LIST OF DEVIATIONS

BRIGHT THOUGHTS (pty) Ltd
signature: [Signature]
billing no.
project: DEVIATION TO APPROVED PLAN NO. CE 2303 0034
address: 319 LILIAN NGOYI ROAD
cadastral description: REM OF ERF 756 OF DURBAN

AS SHOWN
sheet no. V1
job no. n23-05-wd1
date 27.08.2023

ROOF PLAN SCALE 1/100

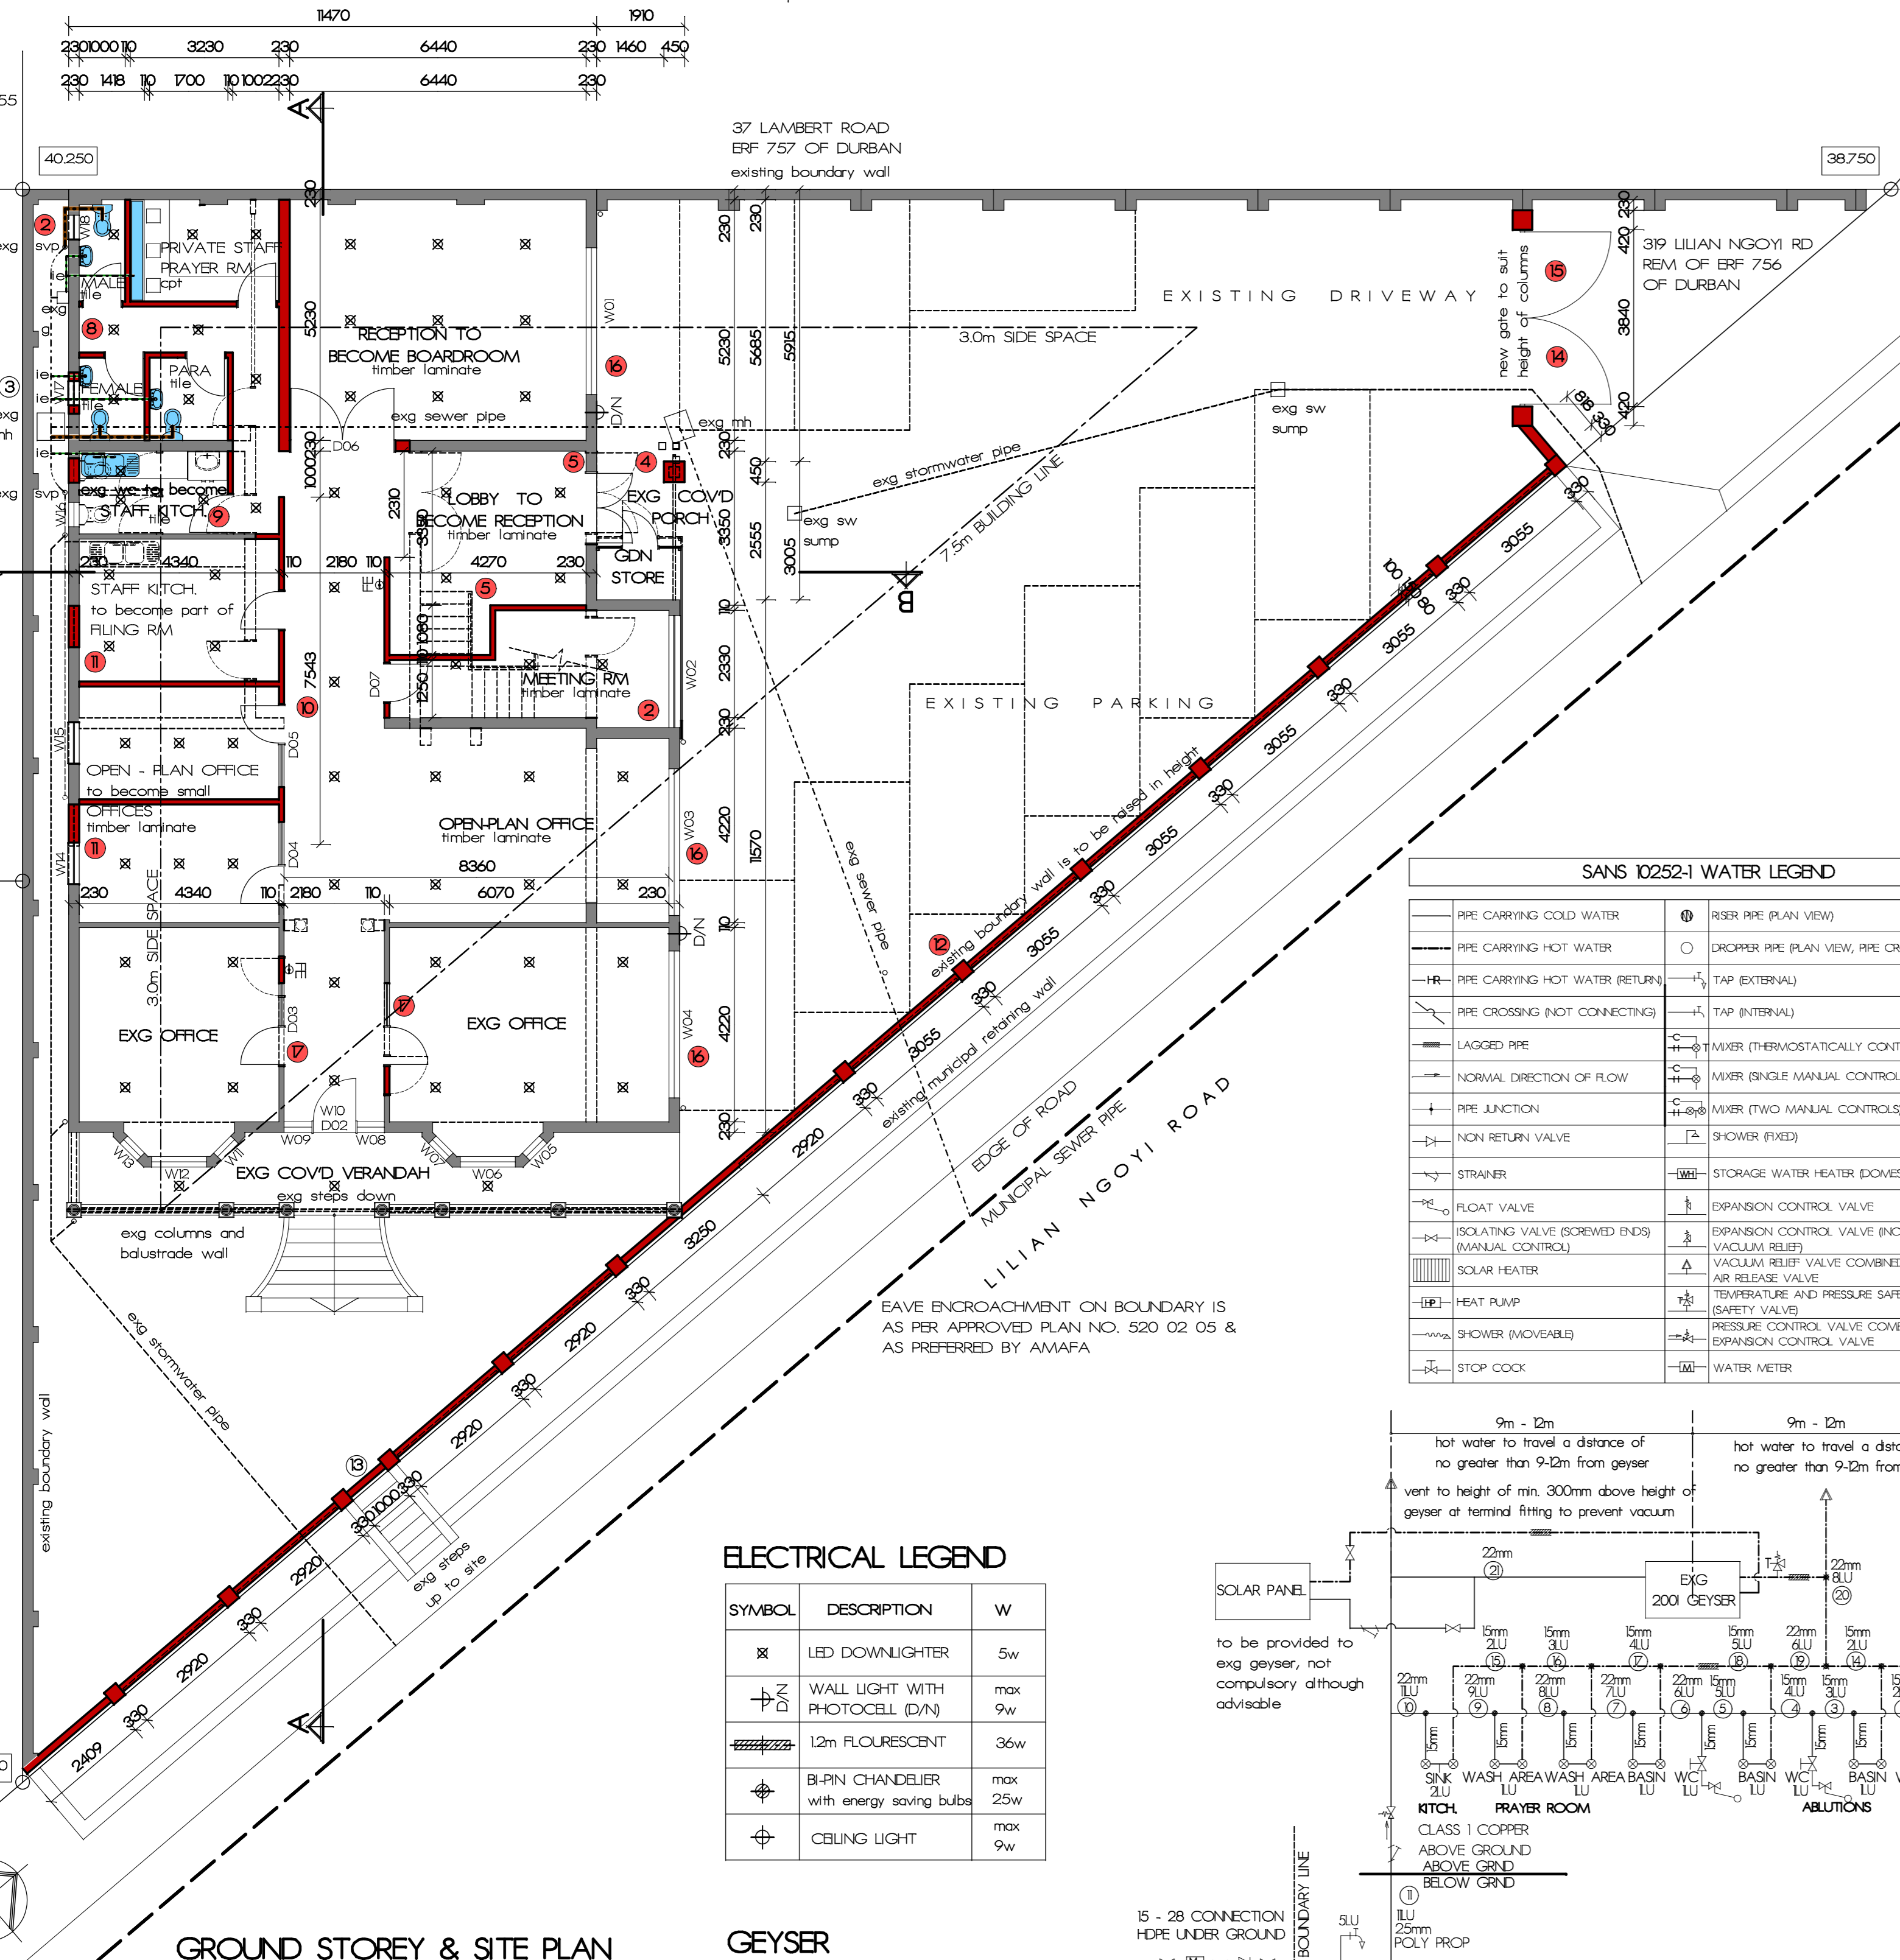
6. STAIRCASE TO BE OMITTED.
7. ROOF PLAN TO BE ADJUSTED TO SUIT GROUND STOREY & TO MATCH ORIGINAL EXG STRUCTURE, PRIOR TO APPROVED PLAN NO. 2303 0034
8. EXISTING BOARDROOM TO BECOME ABUCTIONS & PRAYER ROOM.

GEYSER

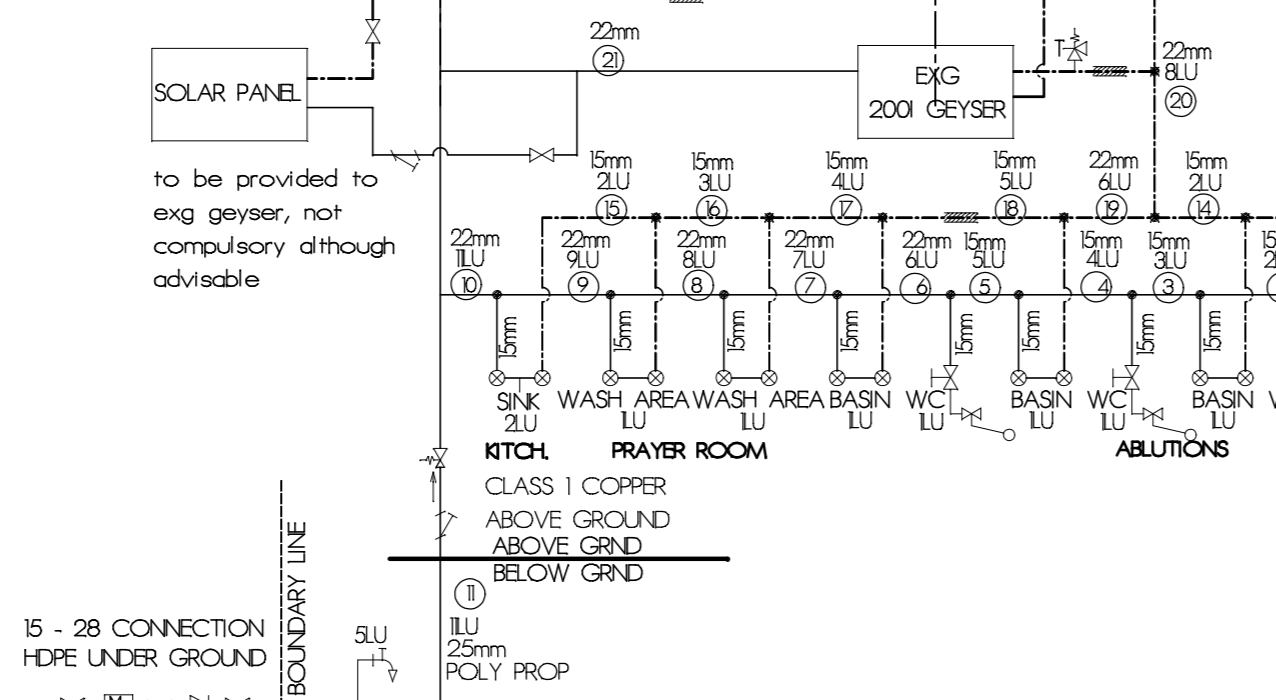
existing geyser to be re-used
provide blanket to existing geyser
client to consider solar power and/or heat pump to heat existing geyser.

EAST BOUNDARY WALL ELEVATION SCALE 1/100

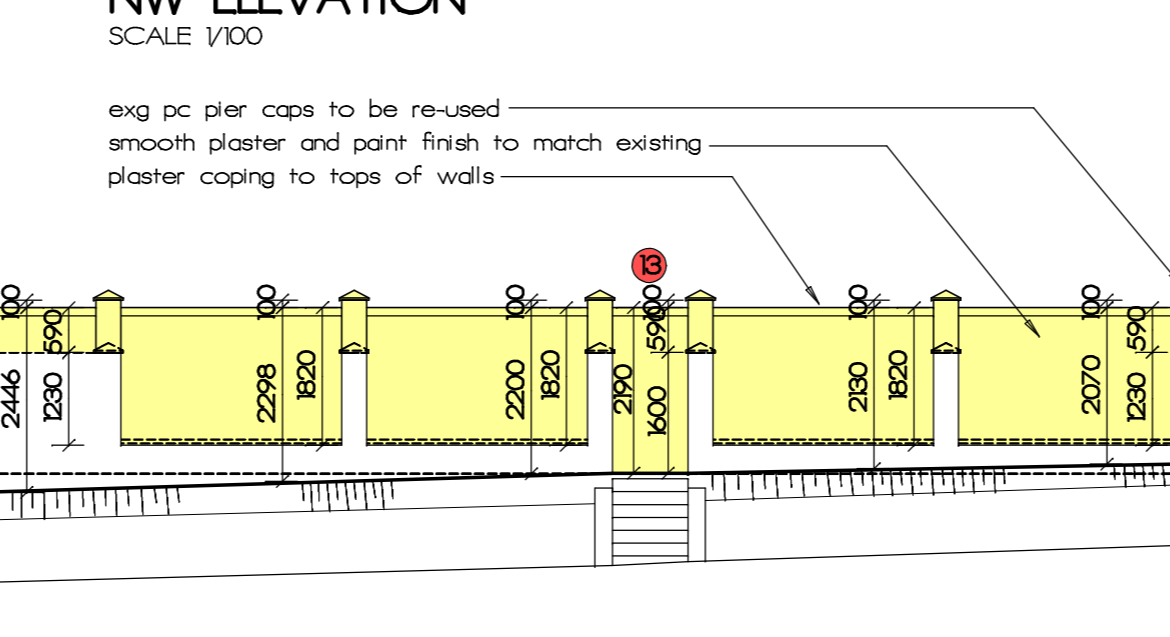
9. EXISTING ABUCTIONS TO BECOME NEW KITCHENETTE.
10. INTERNAL ALTERATIONS ARE TO BE AS PER PLAN.
11. WINDOW TO BE RE-POSITIONED.
12. EASTERN BOUNDARY WALL TO BE RAISED IN HEIGHT.

NE BDRY WALL ELEV. SCALE 1/100

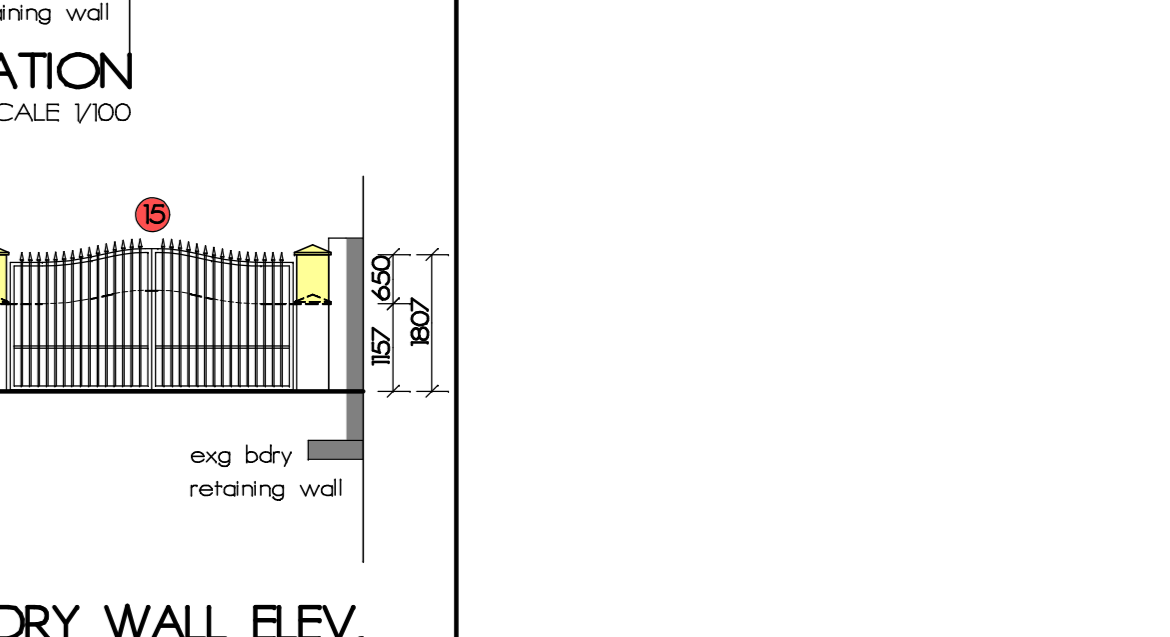
13. PEDESTRIAN ENTRANCE TO BE BROCKED UP.
14. NE BOUNDARY WALL TO BE RAISED IN HEIGHT.
15. GATE TO BE MADE TO FIT NEW HEIGHT OF PIERS.
16. W/O1, W/O3, W/O4 TO BE FIXED FULL PANE WINDOWS WITH A MINIMUM THICKNESS OF 6mm, AND FIXED ON ALL 4 SIDES TO MATCH THE ORIGINAL HOUSE PRIOR TO PLAN APPLICATION NO. CE 2303 0034
